PROPOSED CHRISTMAS FARM, LAND TO THE SOUTH OF LLAY ROAD, CEFN-Y-BEDD, WREXHAM

PLANNING APPLICATION REFERENCE P/2022/0681

ENCLOSURE 1 – LHA COMMENTS DATED 03/02/23

MEMORANDUM

ENCLOSURE 3 - DRAWING NO. 3034-01-ATR01B: SWEPT PATH ANALYSIS

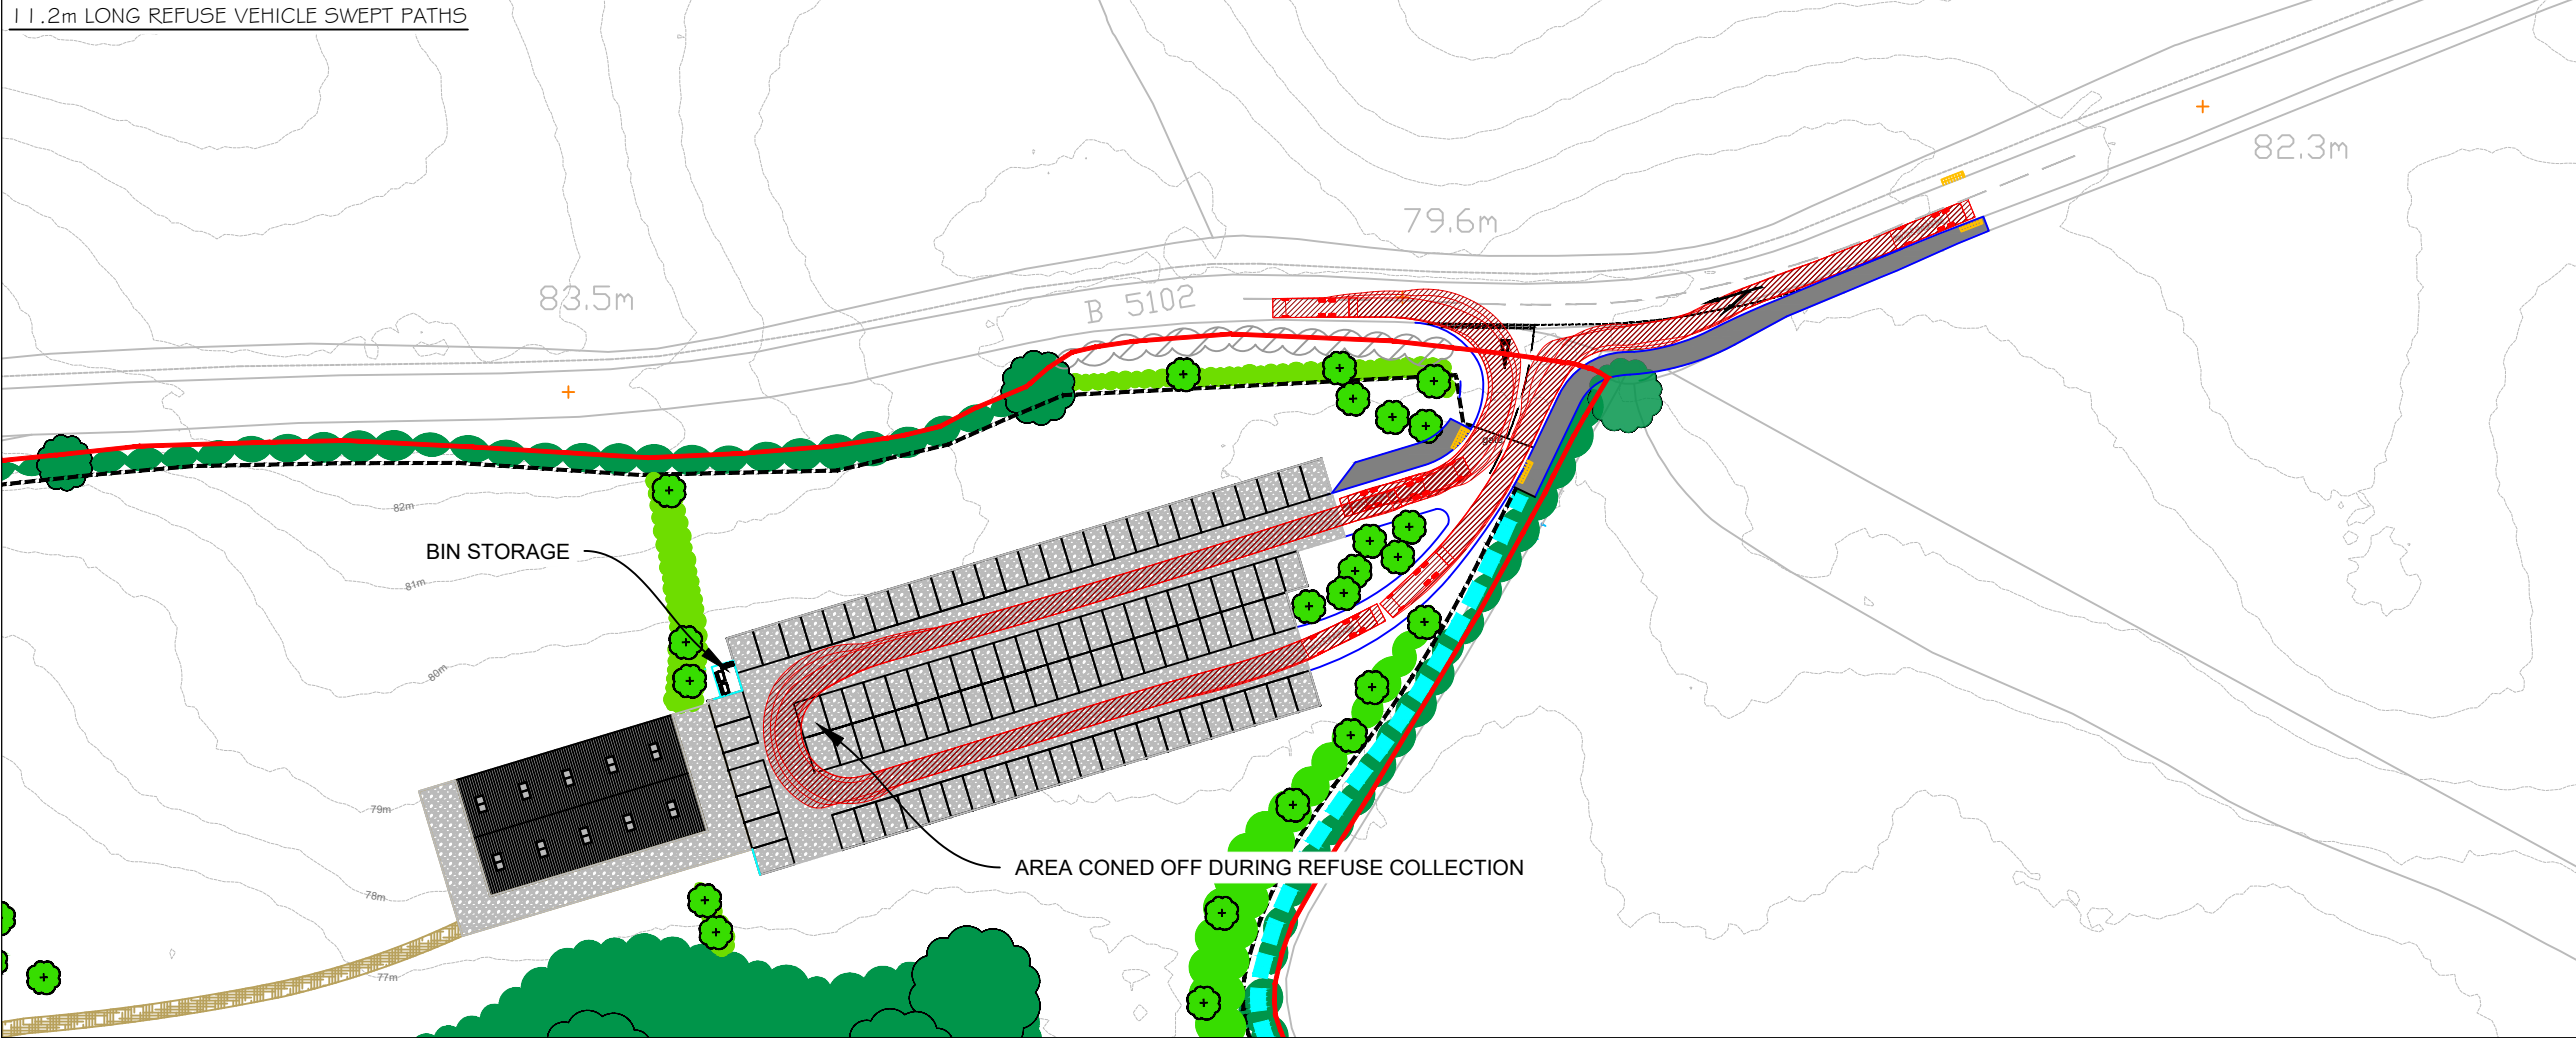
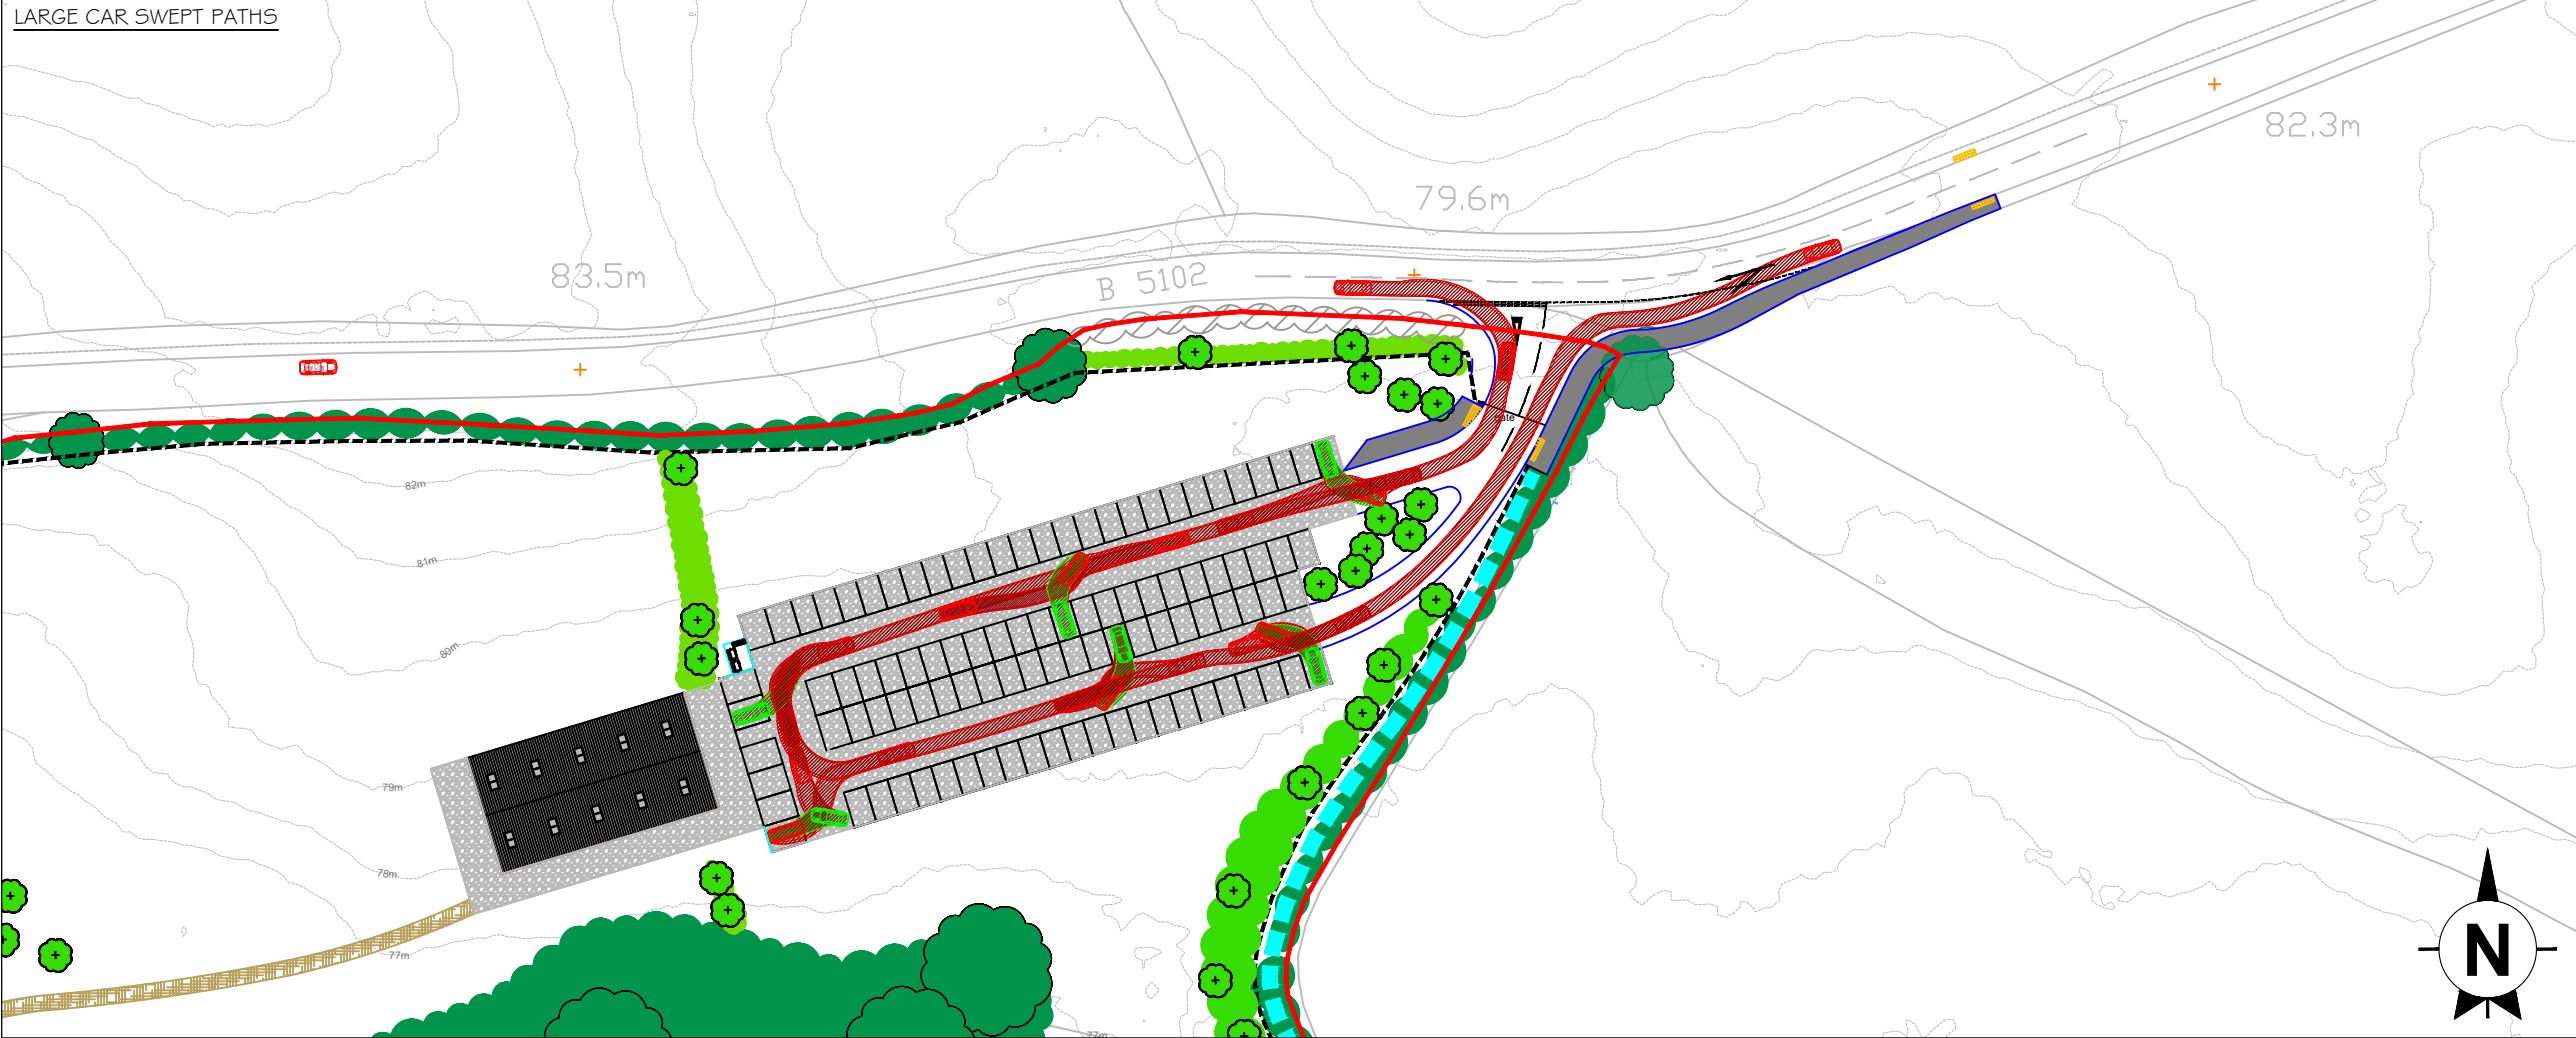
Comment 4: "Sustainable travel to the proposed development is encouraged however, it is noted that the existing footway on the northern side of Llay Road is narrow and not suitable for all users. The applicant has provided detail regarding Active Travel improvements proposed, as discussed, and agreed with WCBC's Active Travel officer (Daniel Morris). Although there is an aspiration to introduce Active Travel infrastructure on the northern side of Llay Road there are currently no designs drawn up. Timescales for the delivery of improvements to the footway on Llay Road should be clarified as if the development site becomes popular and visitors choose to walk to the site, the current arrangements are not adequate."

Details of where refuse / recycling is to be collected from and facilities proposed have been provided and agreed with WCC's Waste Strategy Officer (Catherine Golightly). A swept path drawing (Drawing No. 3034-01-ATR01A) has been provided indicating that a refuse vehicle can enter and exit the site safely. It is shown that on refuse collection days some parking will need to be coned off by staff of the development to facilitate safe passage of the refuse vehicle internally.

Nonetheless, further improvements to the footway and crossing arrangements have been made to the proposed site access drawing (shown on **Drawing No. 3034-01-D02B** in **enclosure 2** and **Drawing No. 3034-01-ATR01B** in **enclosure 3**), which are considered to be proportionate to the modest scale and nature of the proposed development.

Revision History		Date
A	FOOT / CYCLE ARRANGEMENTS BASED ON COMMENTS PROVIDED BY ACTIVE TRAVEL OFFICER	03.11.22
B	FOOTWAY EXTENDED TO EAST	17-2-23
